SECTION 4.55 APPLICATION
33 UPPER CLIFFORD AVENUE
LOT C DP 102834 FAIRLIGHT
DA166/2015

S4.55 APPLICATION DRAWING LIST

DEVELOPMENT CONSENT DA-166/2015
NORTHERN BEACHES COUNCIL
DEVELOPMENT MODIFICATION MOD2018/0715
BASIX CERTIFICATE No A336197_03

S4.55 APPLICATION
ADDITIONS & ALTERATIONS
33 UPPER CLIFFORD AVENUE
FAIRLIGHT

03 DA APPROVED - EAST ELEVATION
scale 1:100

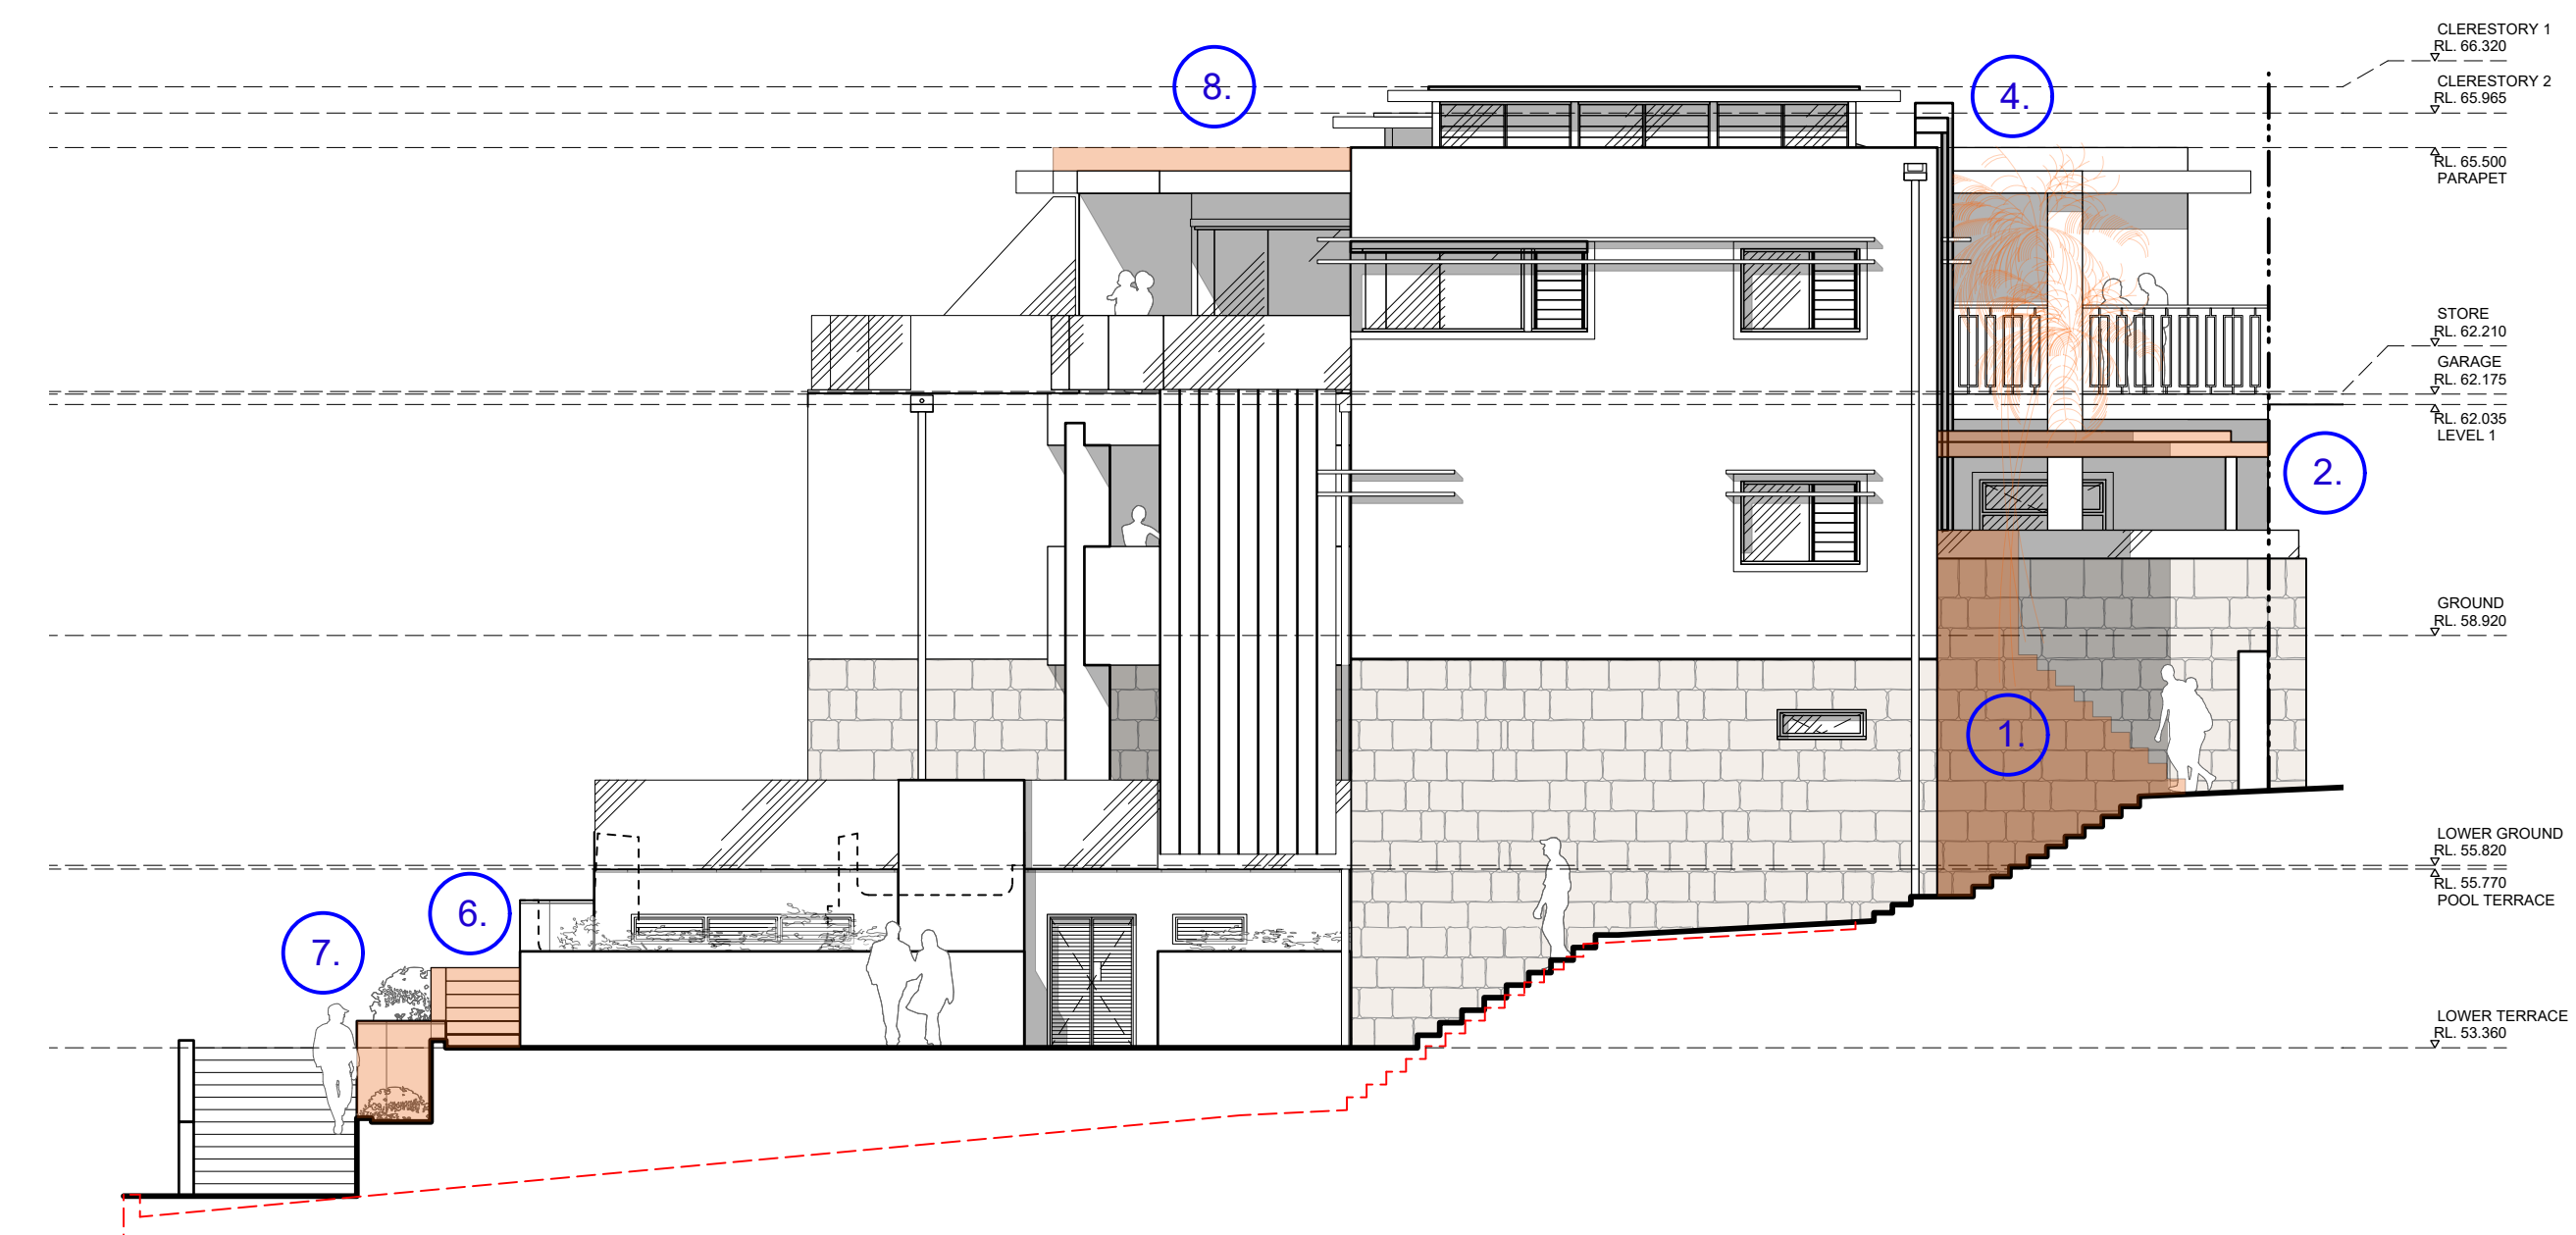
1. REMOVE COURTYARD STAIR ACCESS
2. MINOR INCREASE TO COURTYARD CANOPY
3. REVISED STAIR WELL WINDOW
4. REMOVE EXISTING COURTYARD PALM TREES
5. RELOCATE RAIN WATER TANK
6. ADDITION OF LEVEL CHANGE TO TERRACE PATHWAY
7. MINOR CHANGE TO RETAINING WALL
8. UPDATE ROOF DESIGN TO COMPLY WITH PREVIOUS S4.55 CONDITIONS - REMOVE PART OF PARAPET
